DEVELOPMENT APPLICATION ASSESSMENT REPORT

Application Number:	DA2021/0060
----------------------------	-------------

Responsible Officer:	Catriona Shirley
Land to be developed (Address):	Lot 10 DP 27133, 10 Taminga Street BAYVIEW NSW 2104
Proposed Development:	Alterations and additions to a dwelling house
Zoning:	E4 Environmental Living
Development Permissible:	Yes
Existing Use Rights:	No
Consent Authority:	Northern Beaches Council
Land and Environment Court Action:	No
Owner:	Lenore Anne Walter
Applicant:	JJ Drafting

Figure 2 : Area of eastern side setback non-compliance shown in green.

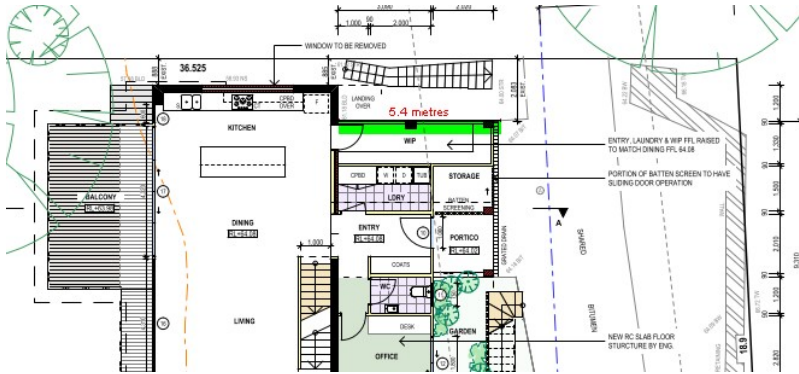
Clause D4.6 of the PDCP requires a minimum side setback of 2.5m to at least one side and 1m to the other. The side setback vary across all three levels and both the west and east boundary from 0.85m

to 10.5m. The non-complying element of this proposal relates to the wall of the walk in pantry at ground level which presents a 2.08m set back for a length of 5.4m to the eastern boundary, see Figure 2 below.

The control includes a variation which allows the maintenance of existing side setbacks where alterations and additions are proposed; given the substantive retention of these existing walls, no concern is raised.

Figure 3: Additional envelope breach on the eastern elevation shown in green, existing envelope breach shown in blue.

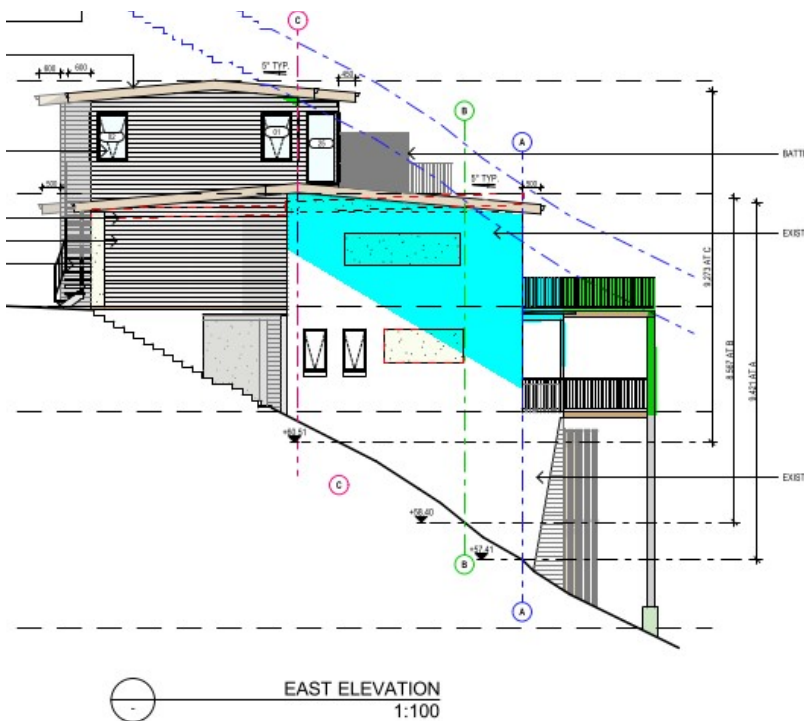
The proposed Upper Floor balcony introduces a new non-compliance with the building envelope control, particularly on the western elevation.

The figures below shows the location and extent of the non-compliance.
